**Project Name** | BCWD Permit 23-05 Mikden of Stillwater / Rocket Carwash**Date** | 04/11/2023**To / Contact info** | BCWD Board of Managers**Cc / Contact info** | Shari Ahrens, Senior Project Engineer / Westwood**Cc / Contact info** | Karen Kill, Administrator / BCWD**From / Contact info** | Camilla Correll, PE; Paul Nation, EIT; John Sarafolean / EOR**Regarding** | Permit Application No. 23-05 Engineer's Report

**Applicant:** Mikden of Stillwater**Permit Submittal Date:** 03/16/2023**Completeness Determination:** 03/30/2023**Board Action Required By:** 05/14/2023**Review based on BCWD Rules effective April 1, 2020****Recommendation: Approve with Conditions**

Figure 1: Site Plan

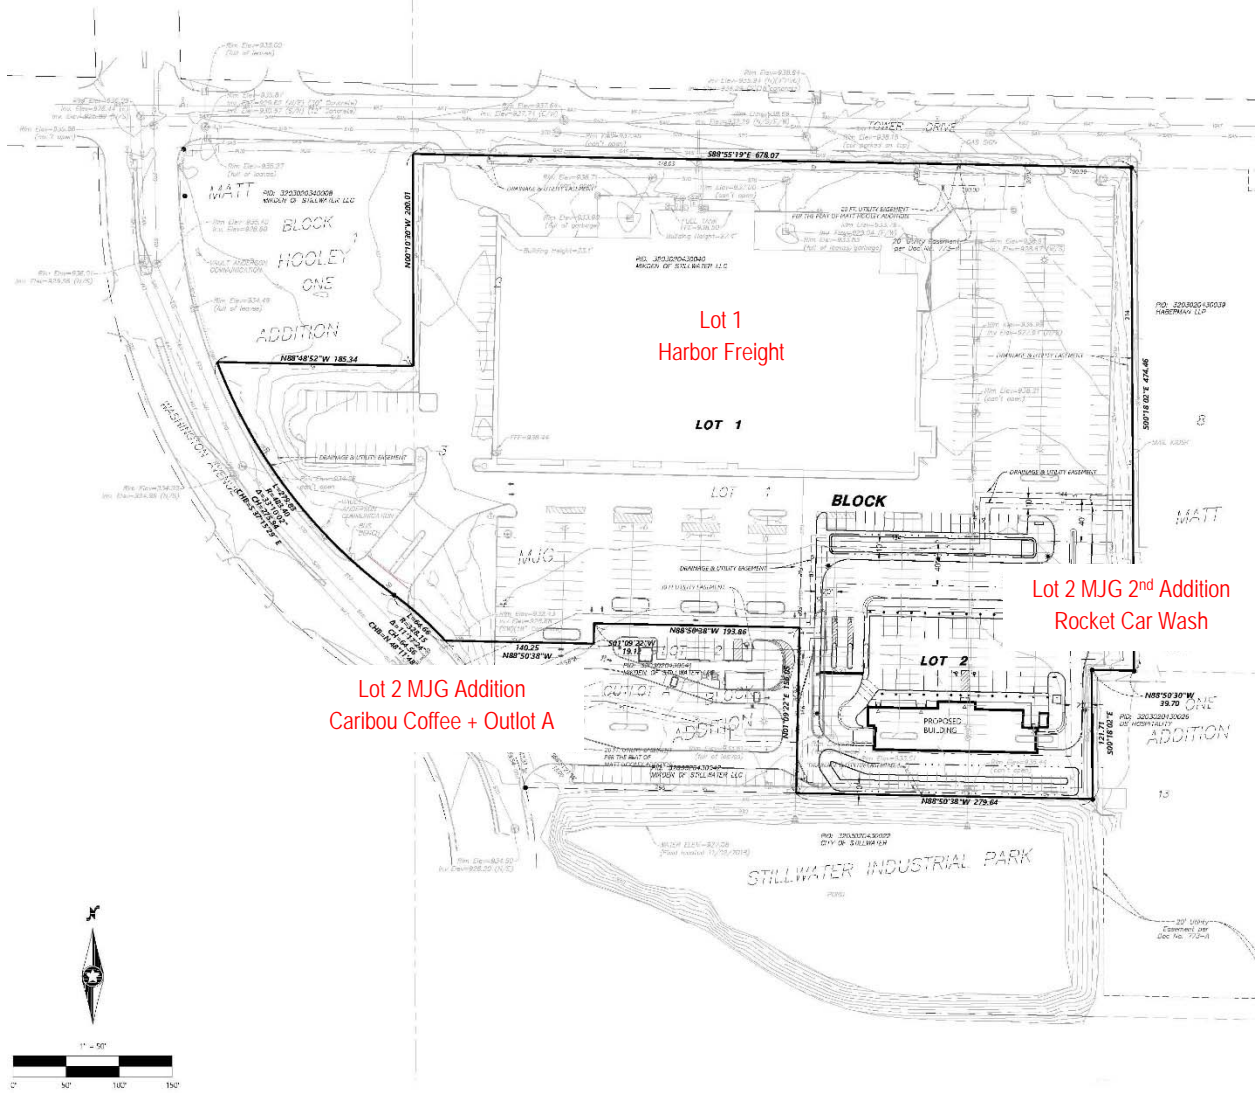
**Proposed Conditions:** The applicant proposes the construction of a Rocket Carwash in the southeast corner of the 8.52-acre Harbor Freight property (Figure 1). The Rocket Carwash is 1.74 acres in size. Following construction of the project, there will be a 36% reduction in the amount of impervious area on the newly created parcel from 1.58 acres to 1.01 acres (Figure 2). As the property owner and applicant (Mikden) acknowledged in the approval process for permit 22-10, changes in the impervious area on the entire 9.52-acre Harbor Freight site are considered in aggregate. Total disturbed impervious for both permit 22-10 and the proposed Rocket Carwash is 1.46 acres. This is less than 50 percent of the total site impervious (8.39 acres) under existing conditions. The 0.45 acres of new and reconstructed impervious for the Caribou site were addressed in the engineer's report for 22-10 and the 1.01 acres of proposed reconstructed impervious area for the Rocket Carwash is subject to the applicable BCWD stormwater-management requirements. Future redevelopment of the original, 9.52-acre, property must be the subject of a separate, future application for a permit

Figure 3. Flood Storage Impacts including both Caribou Coffee (left) and the proposed Rocket Car Wash (right)

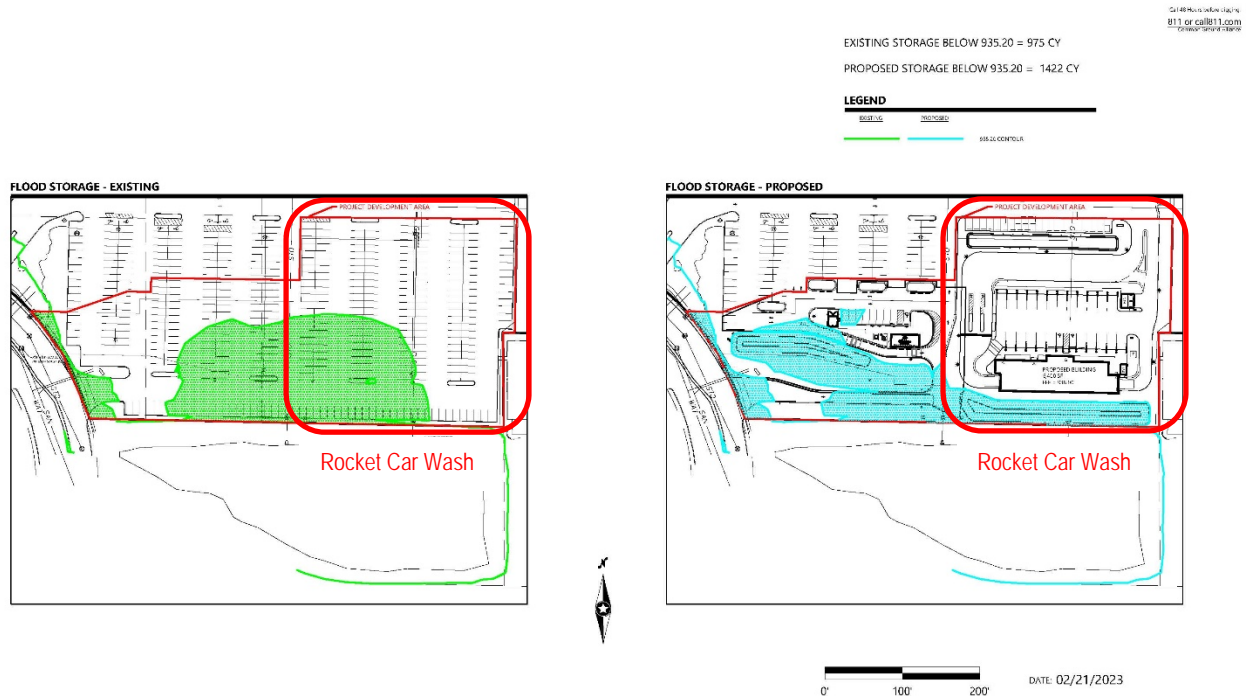
The proposed development is located within the floodplain of Herberger's Pond (i.e., proposed development within the 100-year HWL of 935.2' as reported in the District's H/H model) (Figure 3). As a result, the stormwater management plan must demonstrate replacement of flood volume (7.3.1).

According to Rule 7.2, no person may alter or fill land below the 100-year flood elevation of any waterbody, wetland, or stormwater management basin, or place fill in a landlocked basin, without first obtaining a permit from the District. No person shall alter stormwater flows at a property boundary by changing land contours, diverting or obstructing surface or channel flow, or creating a basin outlet, without first obtaining a permit from the District. The proposed project triggers the application of Rule 7.0 Floodplain and Drainage Alterations because there are land alterations below the 100-year flood elevation of an existing stormwater facility (Herberger's Pond) as shown in Figure 3.

*The floodplain of Herberger's Pond extends into the existing parking lot (Figure 3). As Table 4 demonstrates the replacement flood volume being provided by the filtration basin (Basin B) exceeds the flood volume provided by the parking lot under existing conditions. The filtration basin has been designed to drawdown within 48 hours to ensure that this storage is available for subsequent precipitation events.*
